From:
To:
Cc:
Subject: RE: Phase 7 cvc request for initial clarifications [NLP-DMS.FID262297]
Date: 26 October 2018 16:00:14
Attachments:

NYM/2018/0585/CVC – Phase 7 conditions discharge

Request for initial clarifications

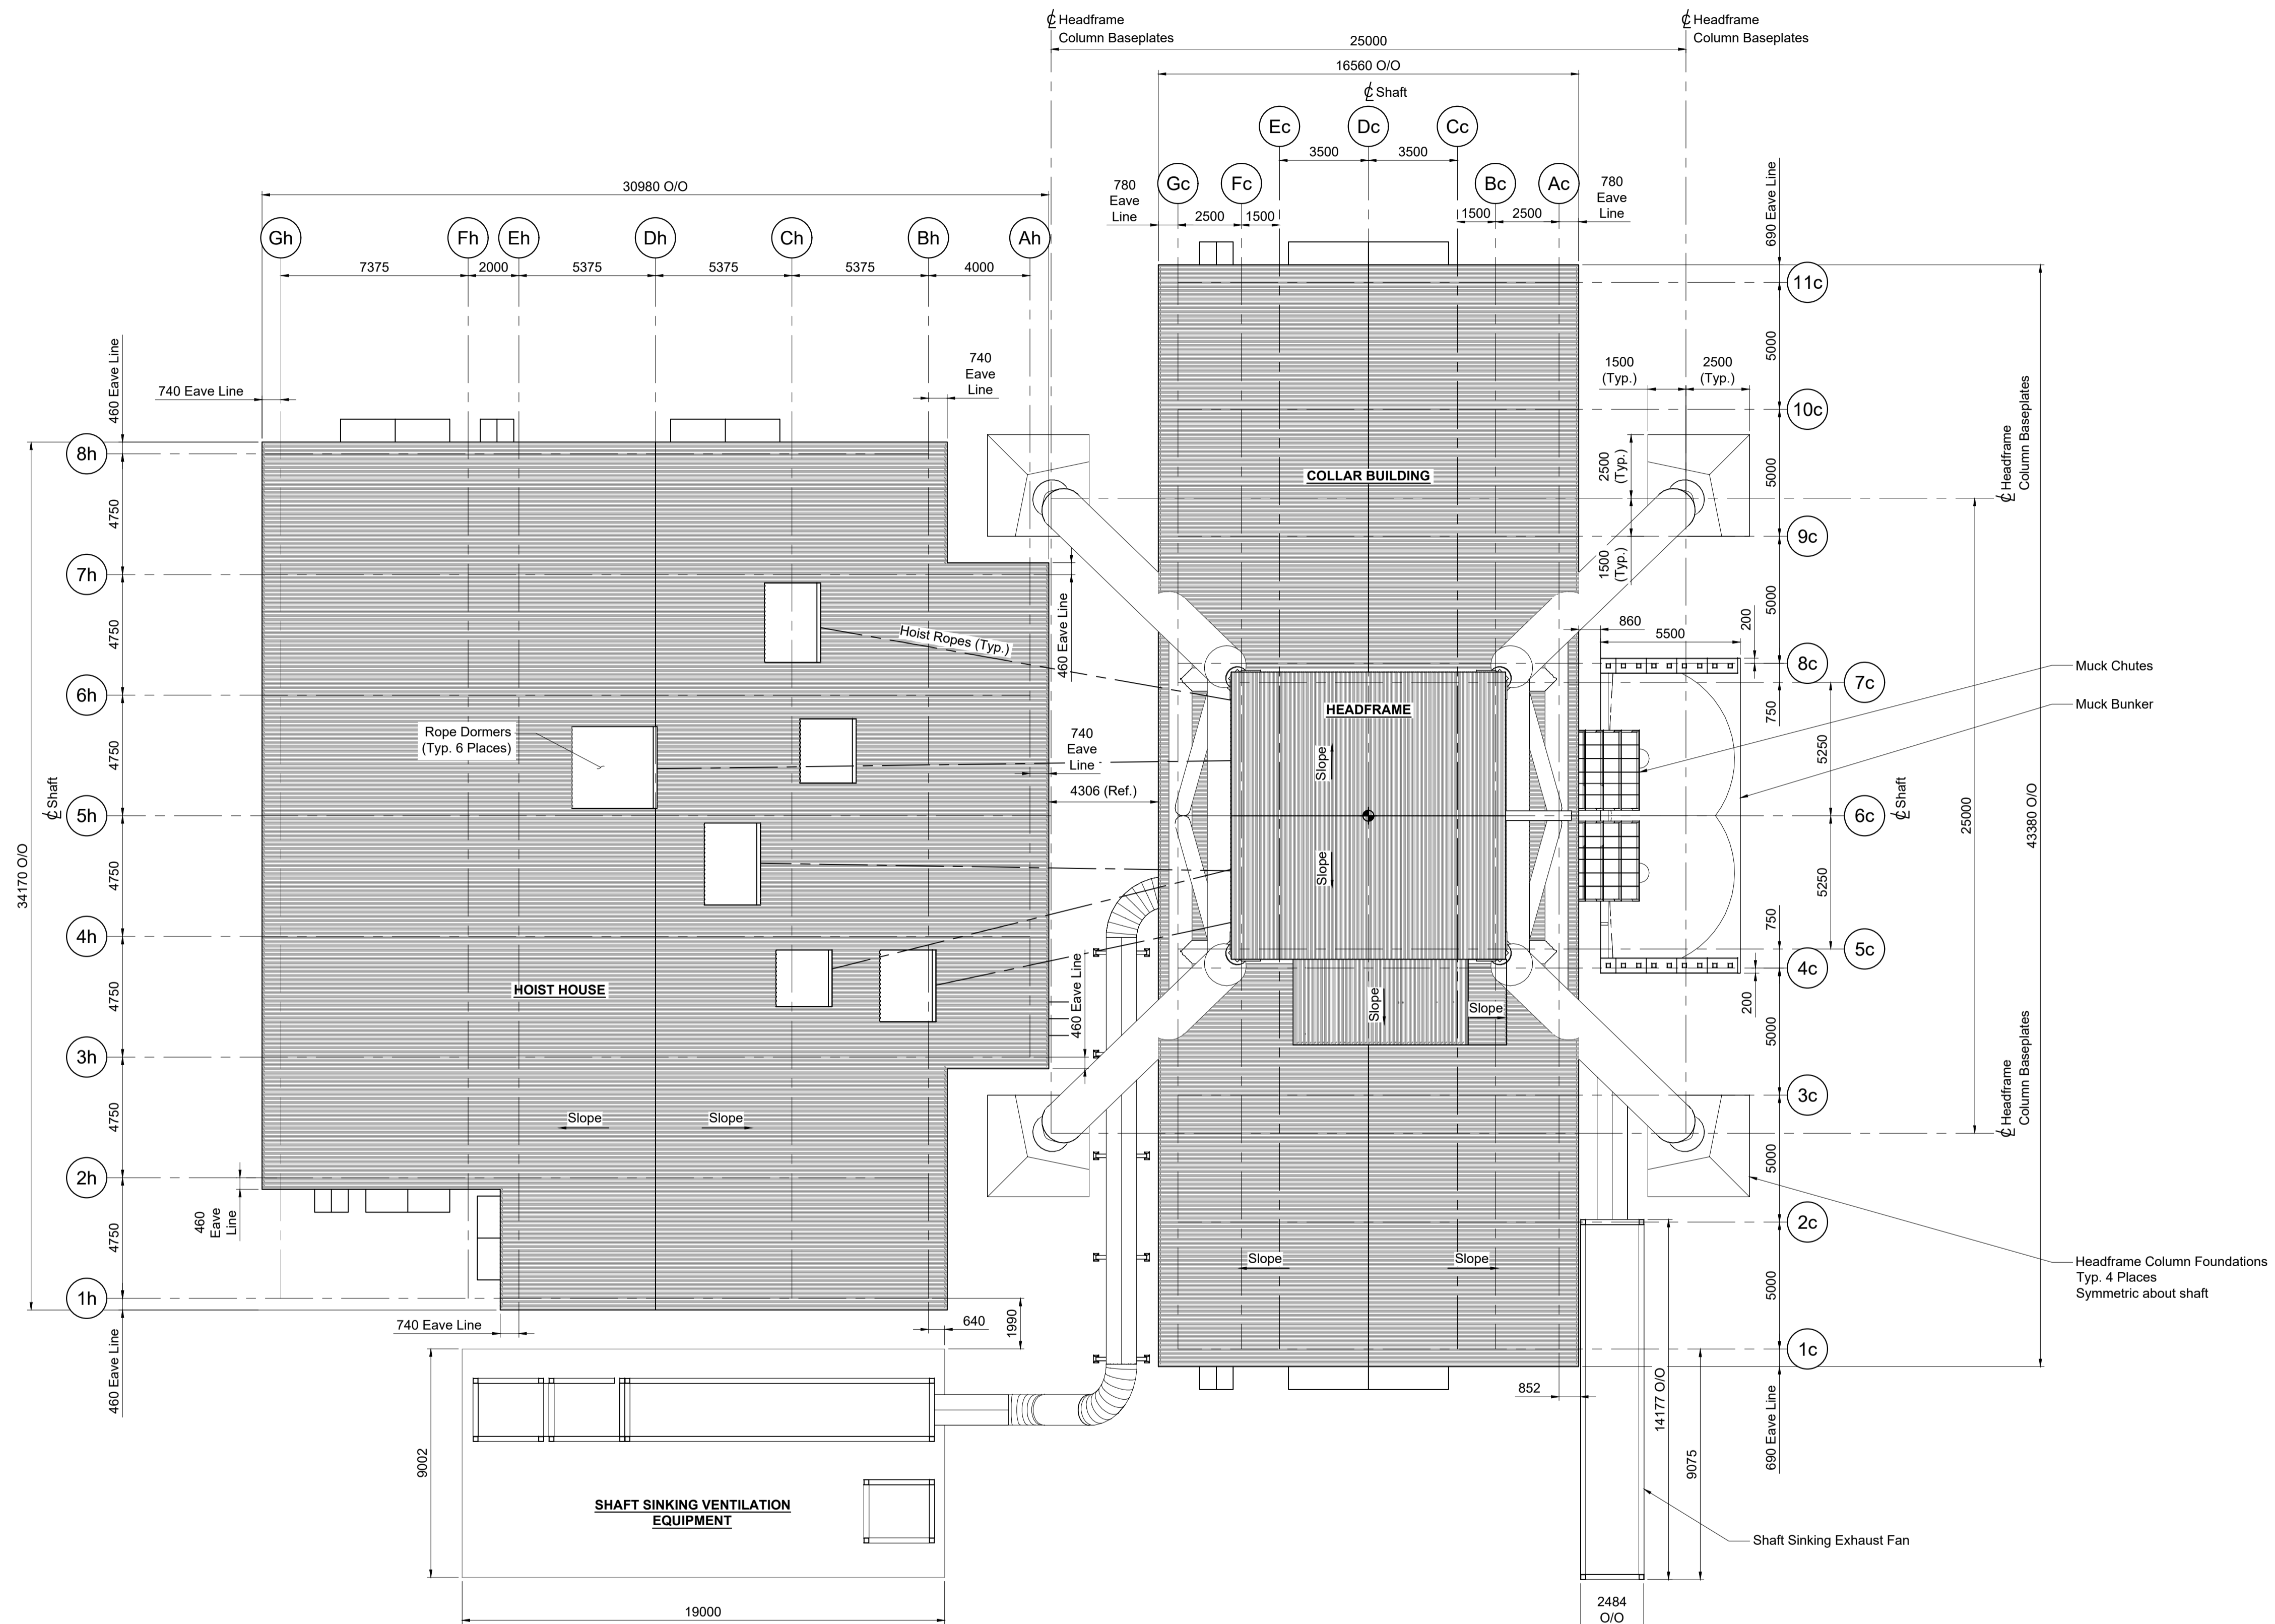
6) Drawing 40-ARI-WS-7100-CI-18-01006 shows a proposed minor realignment of the internal haul road linking the main internal haul road with the northern drainage ponds area. Please could the reasoning for be clarified.

The realignment is necessary to facilitate the construction of the full MTS shaft platform. If the road was to stay on its current alignment, it would bisect the platform, which is not optimal for safe use.

40-DMC-WS-1310-AR-31-00002	Woodsmith Site - MTS Shaft Sinking Mode Surface Facilities South Elevation		
Drawing Number	Reference Drawings	Drawing Number	Reference Drawings

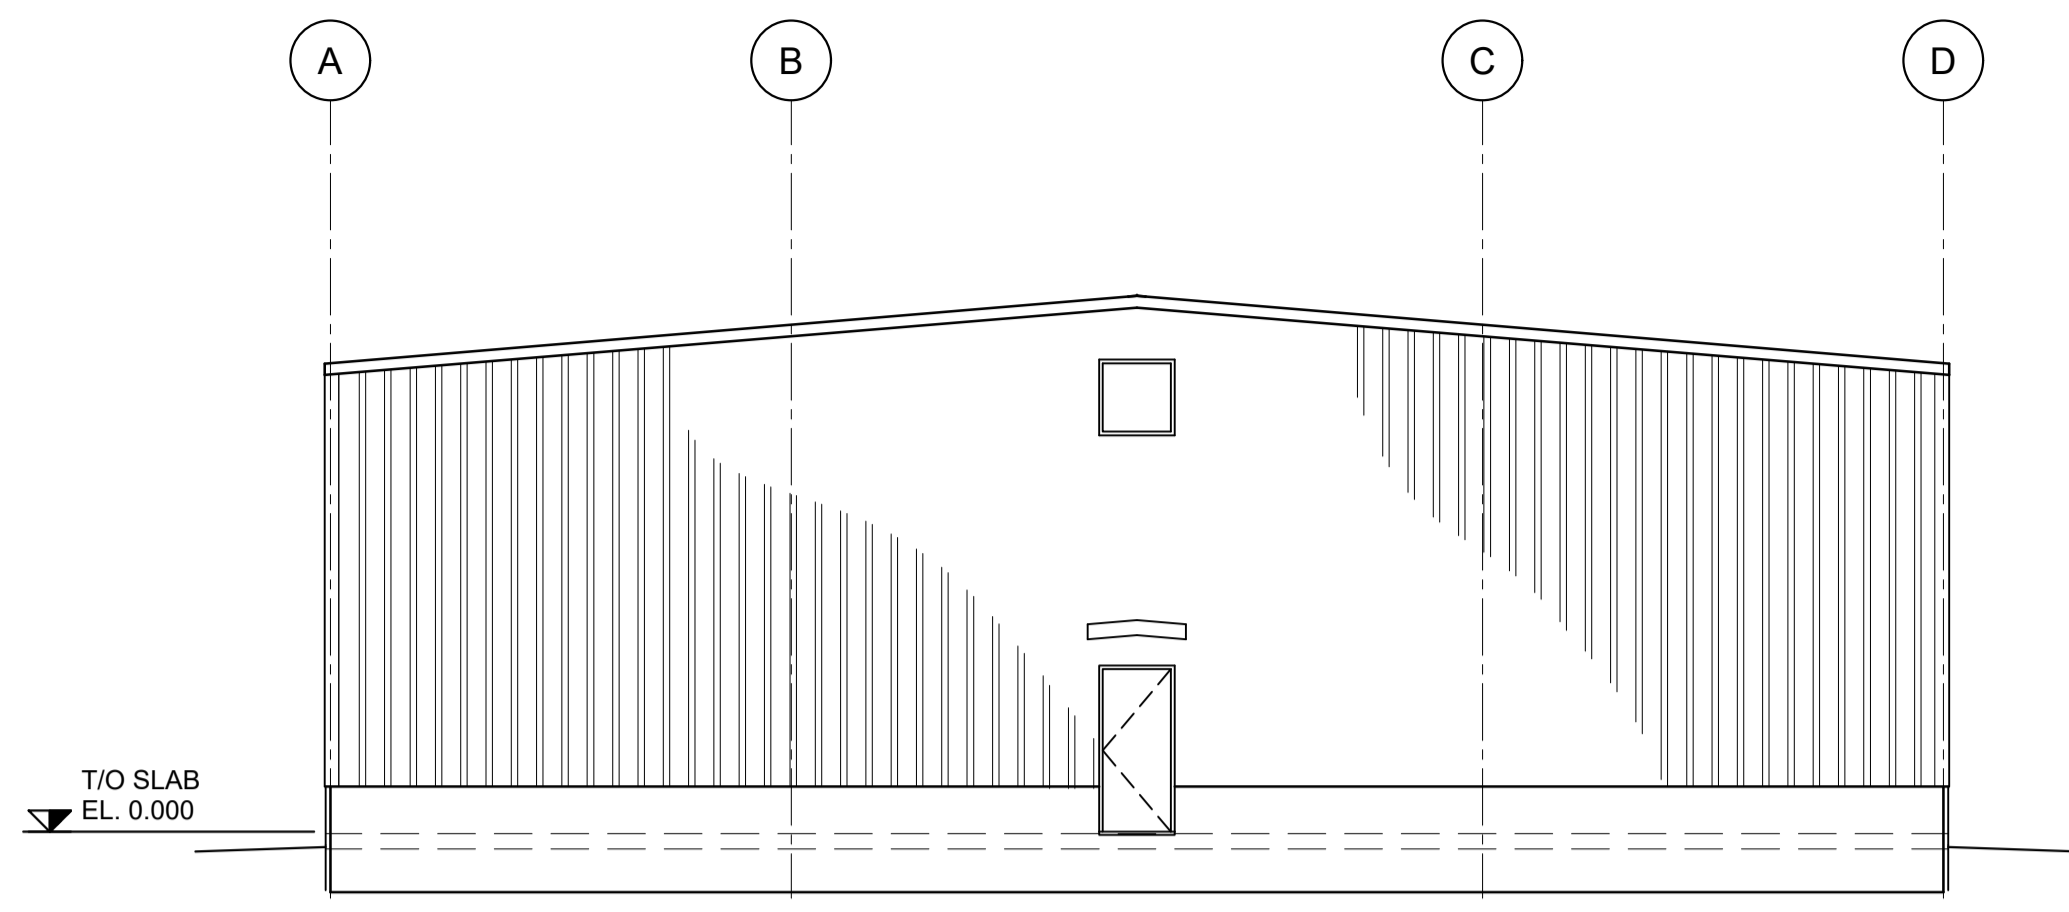
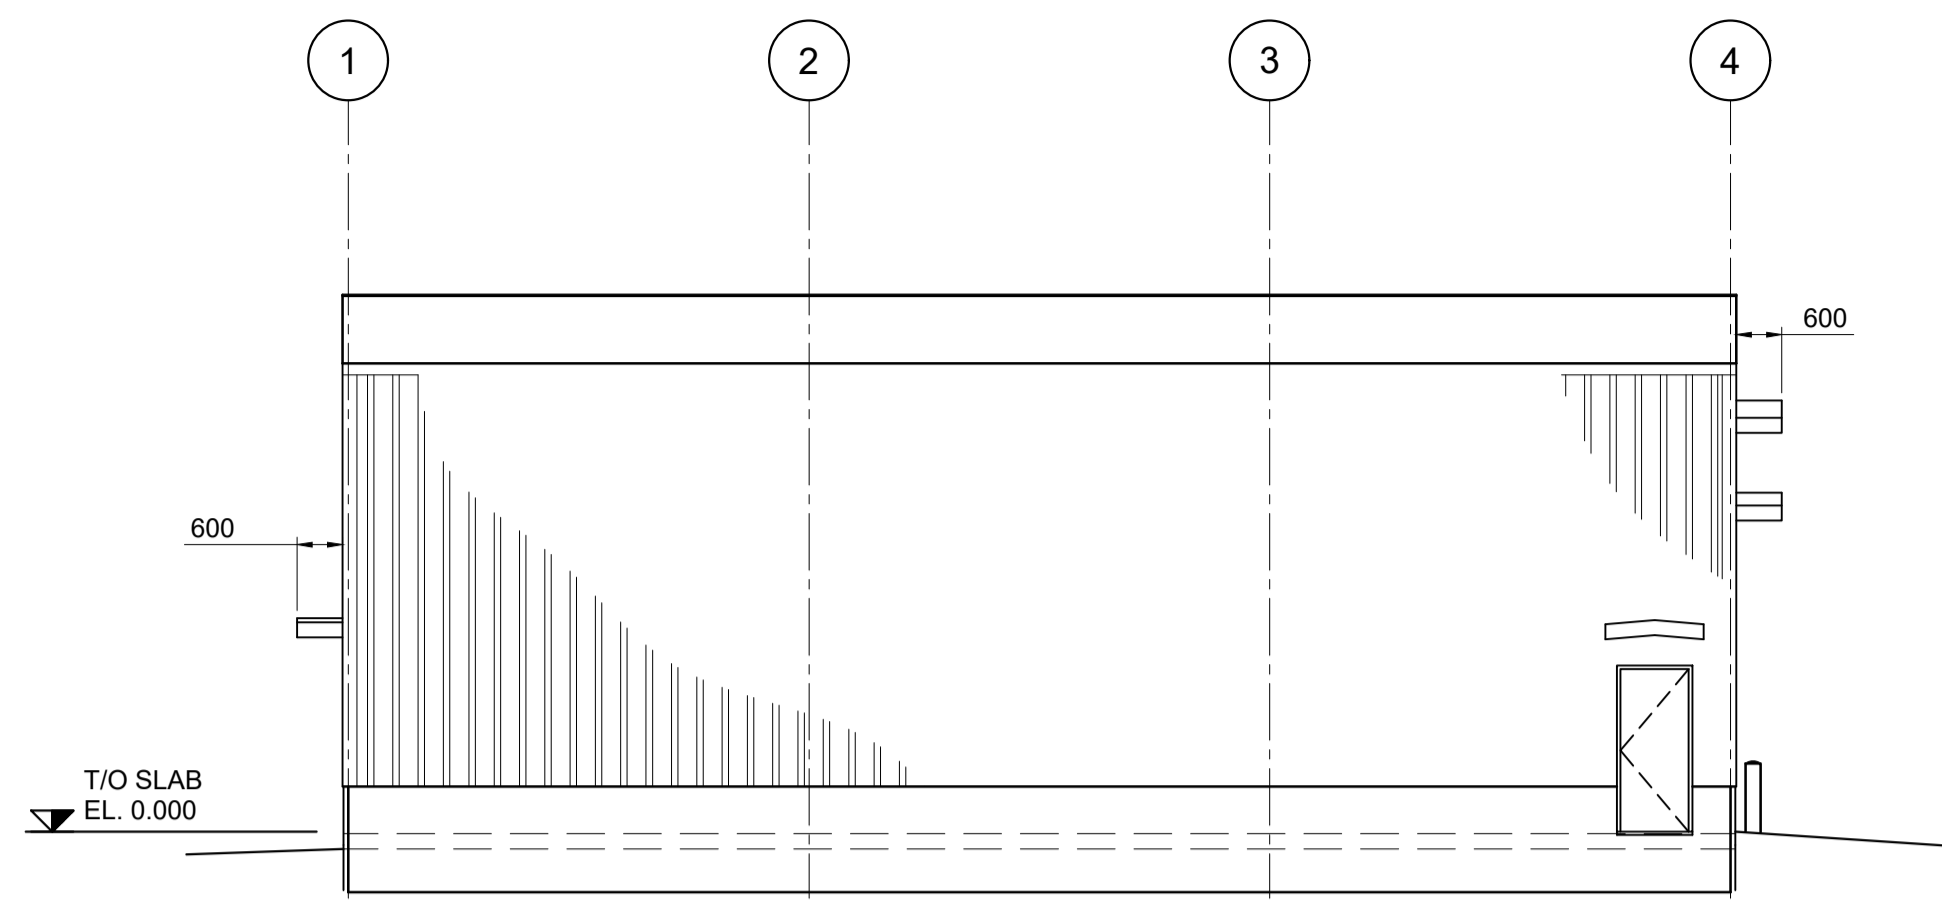
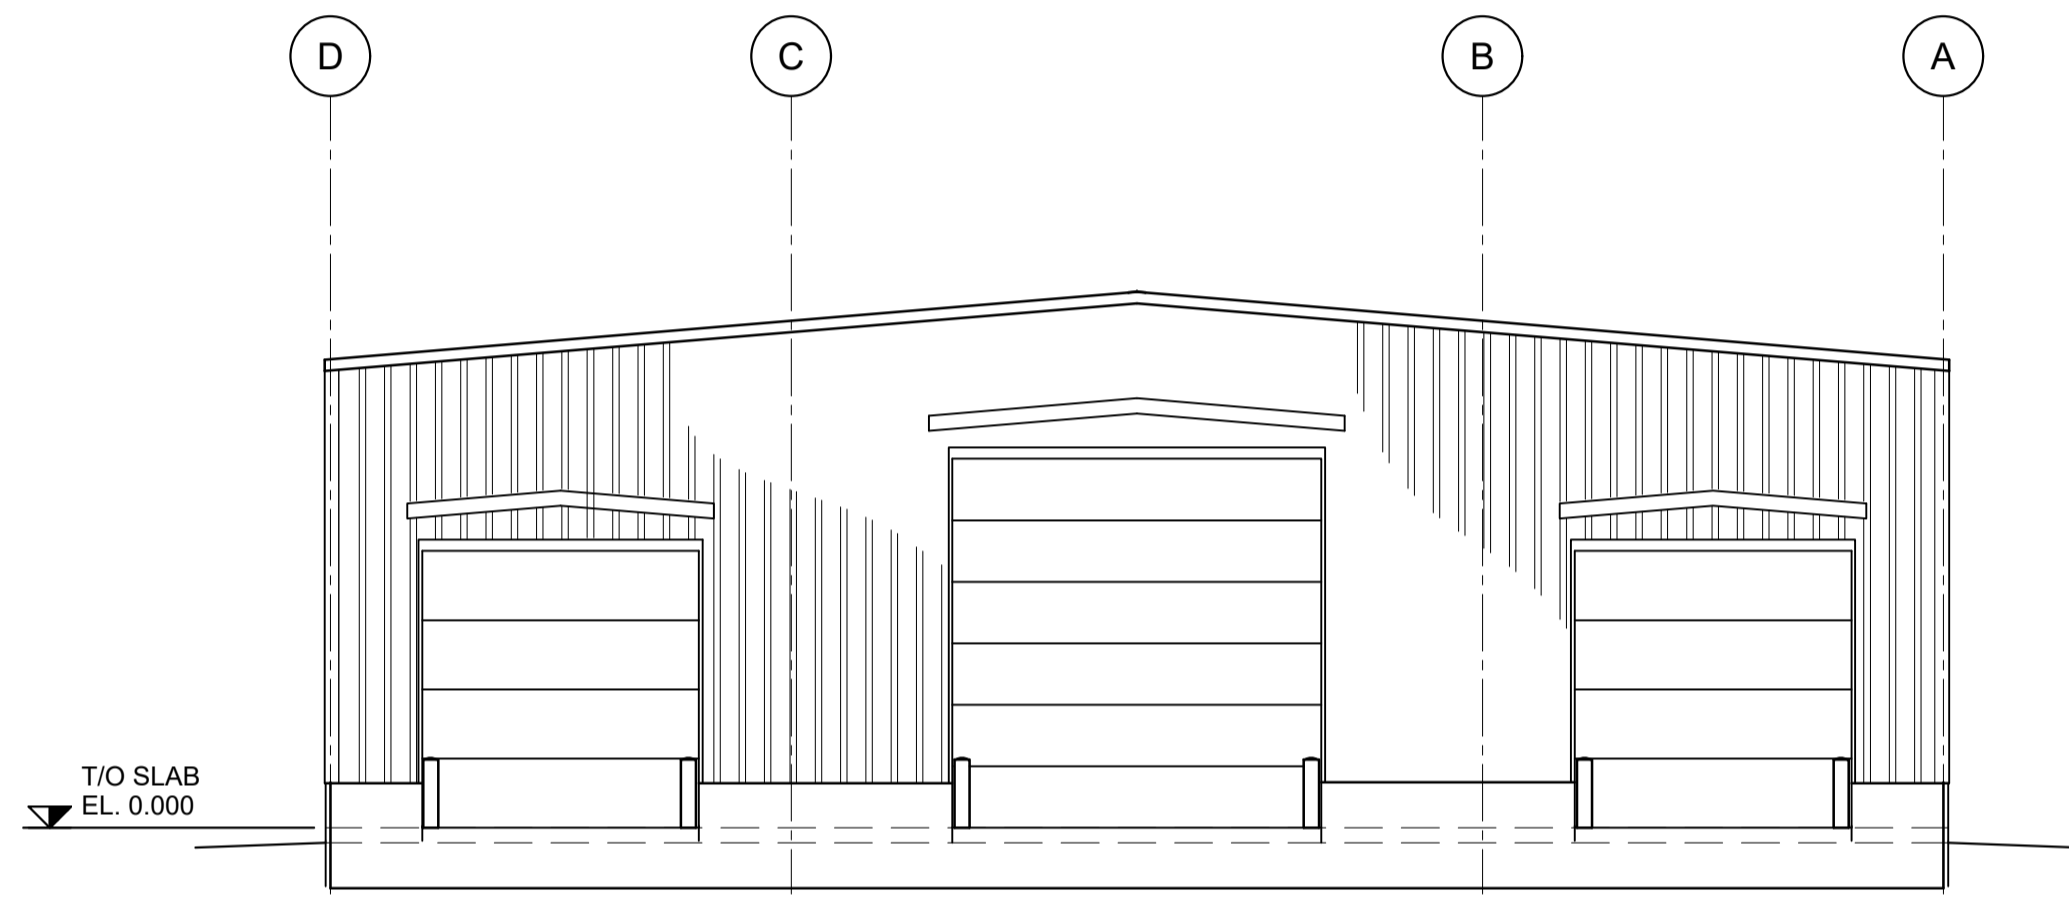
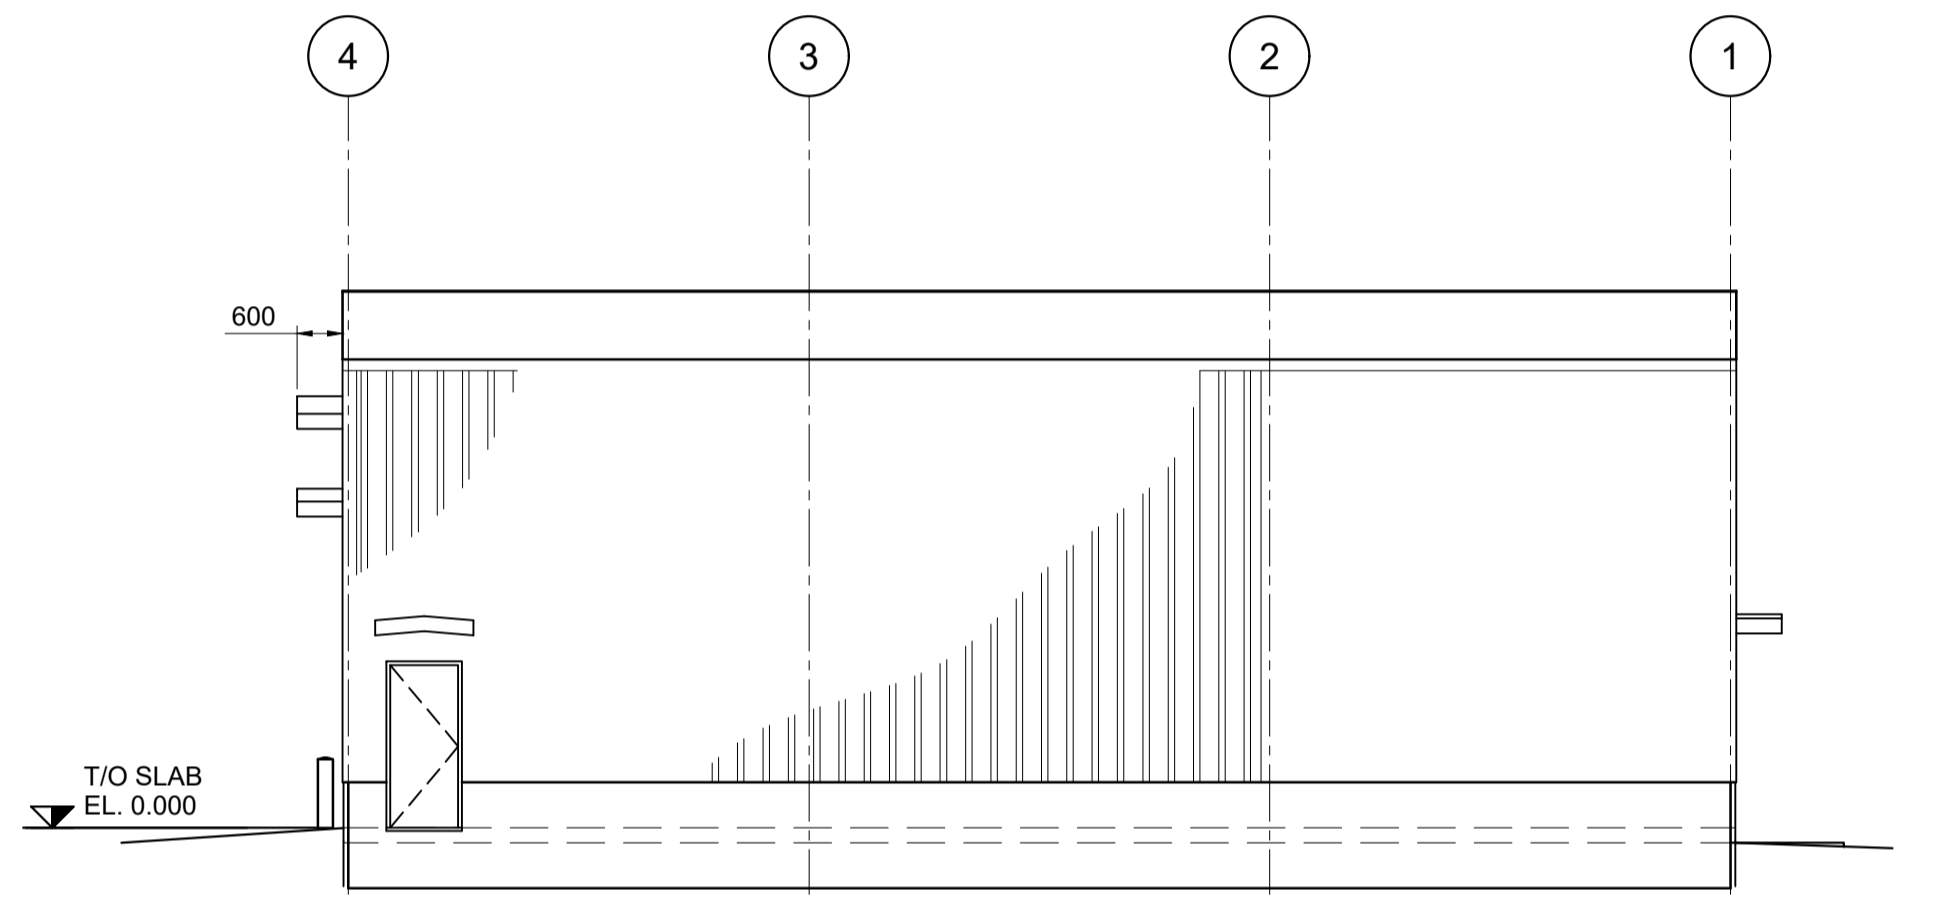
3) It is understood from recent discussion that further illustrative material to demonstrate the appearance of the MTS temporary headframe structure may be available. It would be helpful if this could be provided, together with clarification of any external lighting requirements (other than low level temporary lighting).

The following scaled drawings are attached in response to q. 3:

Building / Structure	Drawing Numbers
MTS Headframe	<ul style="list-style-type: none"> • 40-DMC-WS-1310-AR-31-00002 • 40-DMC-WS-1310-AR-31-00001

External lighting will be limited to low level temporary lighting that accords with the lighting strategy contained within Appendix 11 of the Supplementary ES (June 2017)
